ERDA CITY
2163 W Erda Way – Erda, UT
(435)243-5577

Preliminary Subdivision

Public Body: Erda City Planning Commission

Request Phase 1 preliminary plat approval

4 8' TRAIL CROSS SECTION
SCALE: NONE

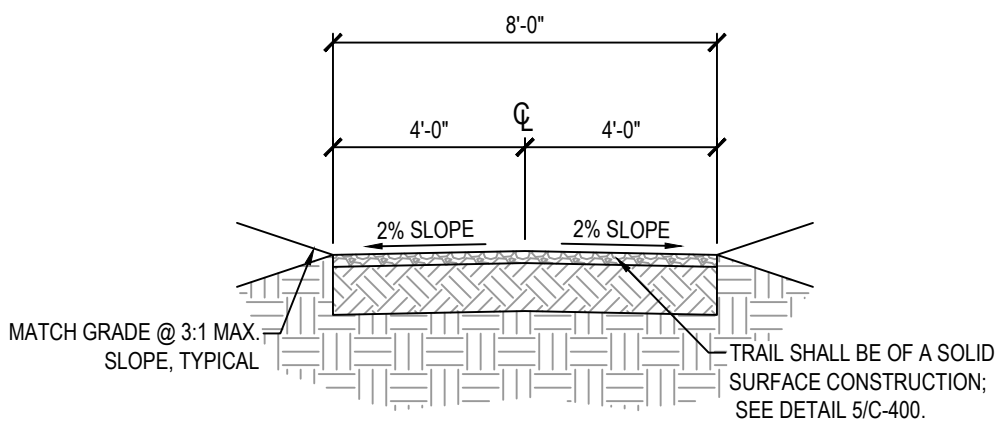
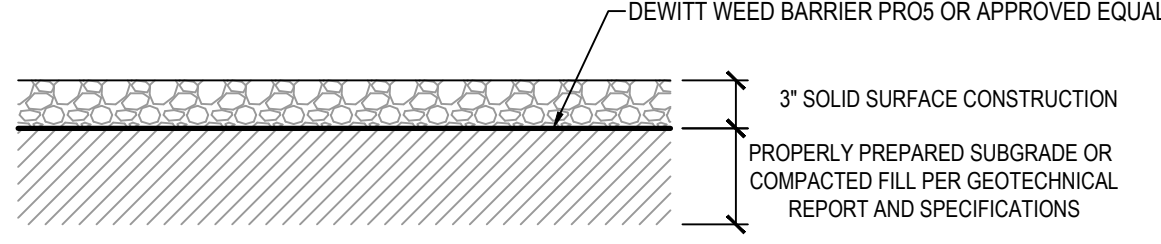
The detail drawings for the trail specify hard surface but do not call out asphalt or concrete. Recommend a condition be made that this is more specific on the final plat to prevent the trail from being compacted gravel.
